Change Order Request

Re: Cora Apartments – Change Order Request #7 Exterior Trench Drains on 1st Ave

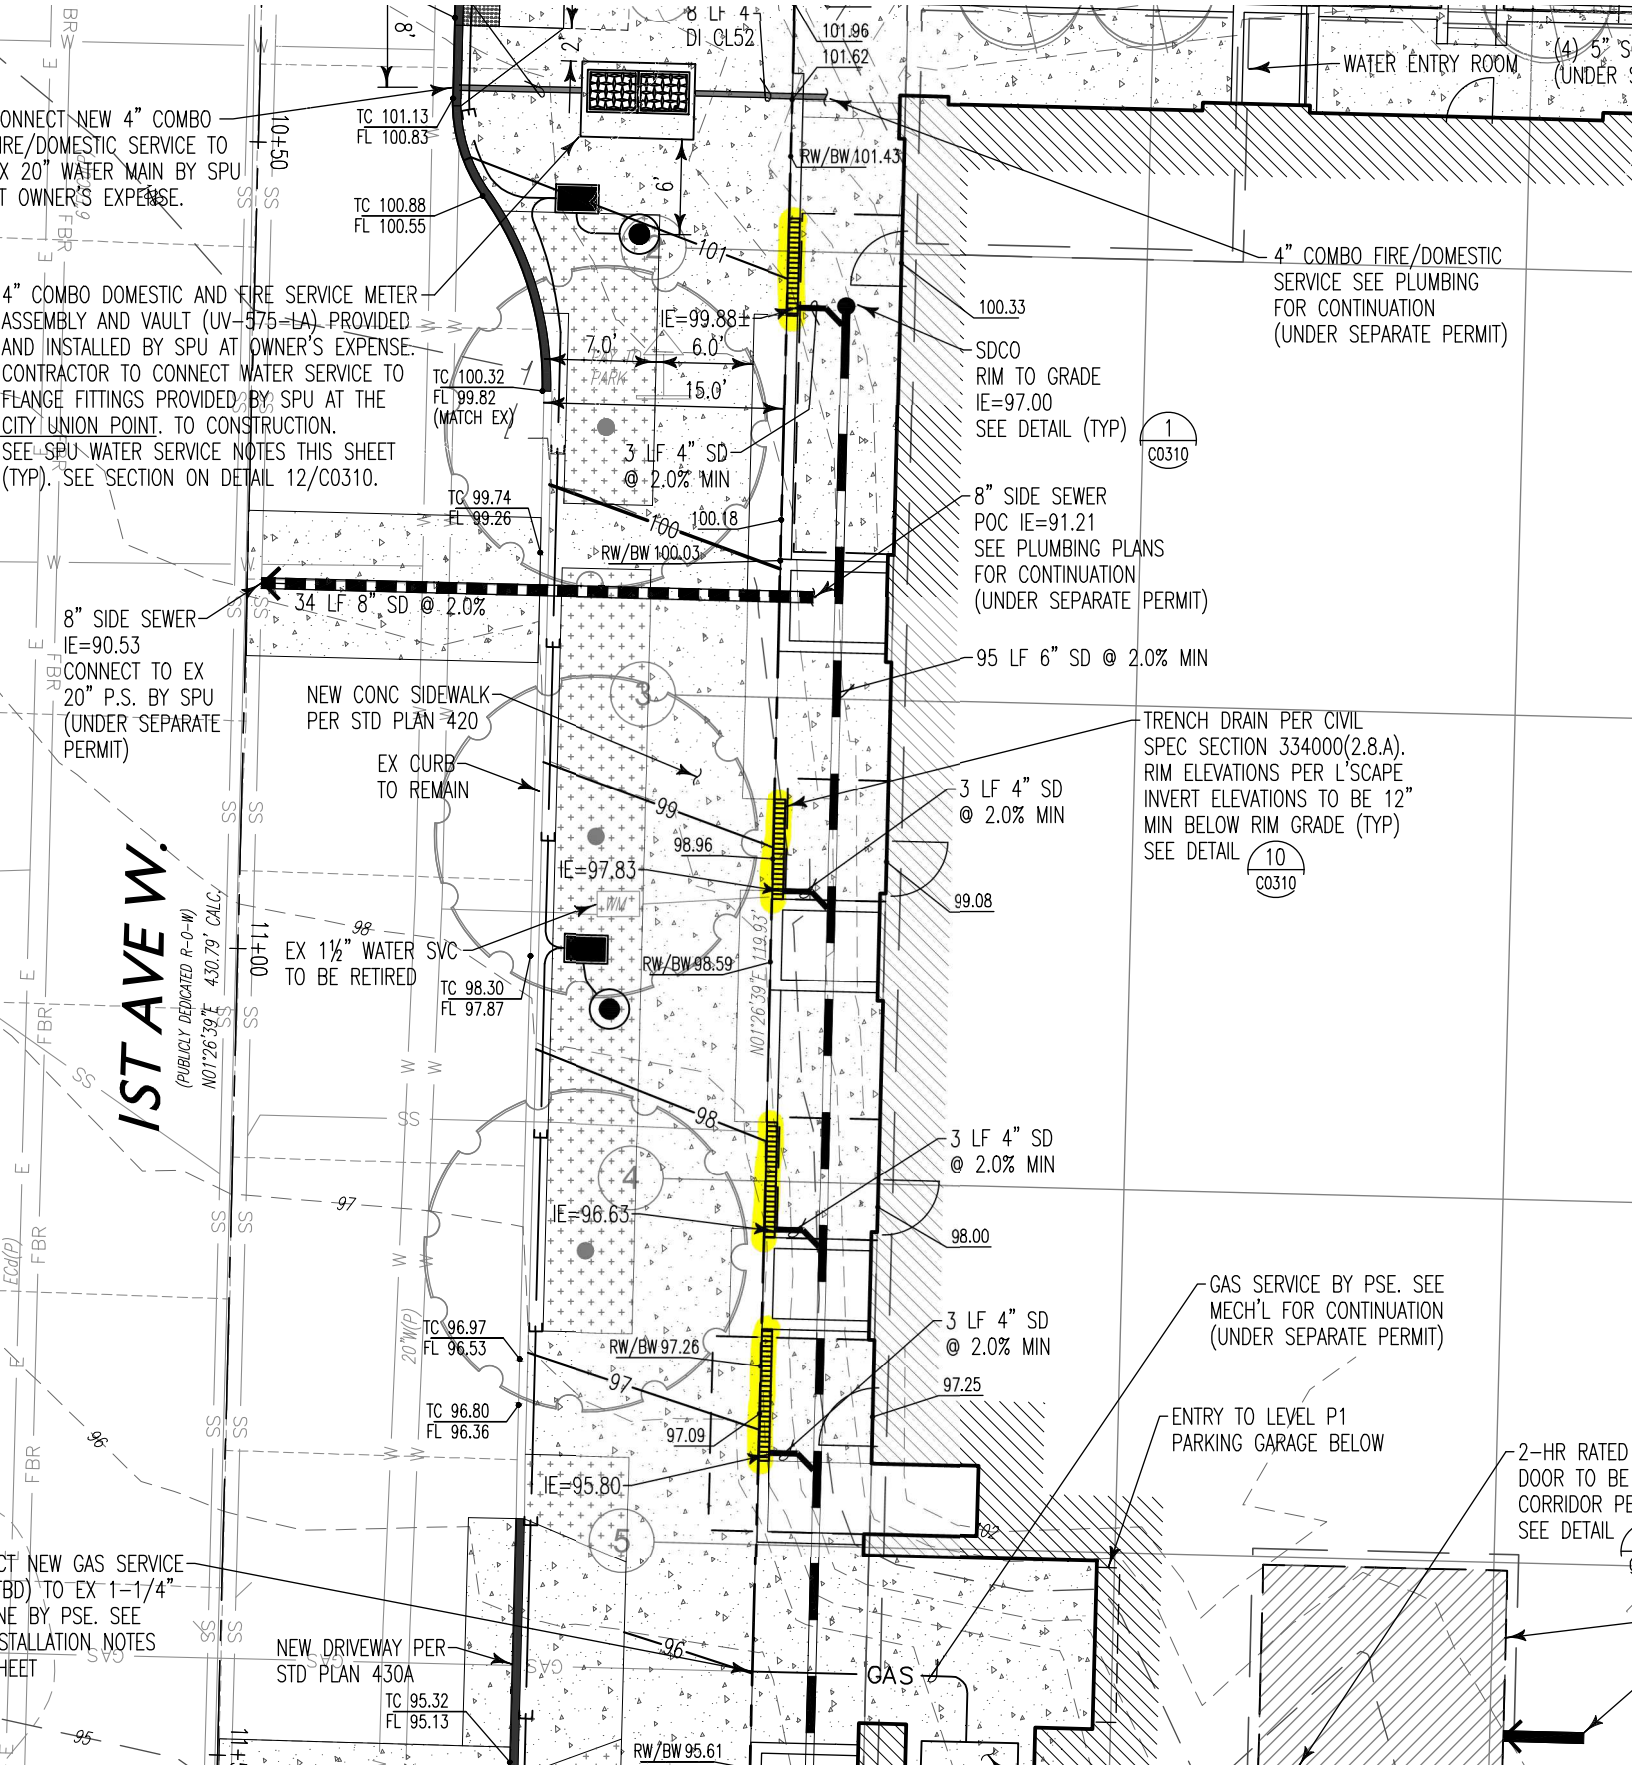
Total cost to install the 4ea trench drains along 1st Avenue West, as highlighted attached, is $$6,853 + 15% OH&P = $7,881. We plan to use NDS DS-090N trench drains and DS-226 stainless steel grates per attached submittal. All mainline storm piping is by others. We will hook up to storm via tee left by others. Trenching/excavation is excluded. We will fine grade only.
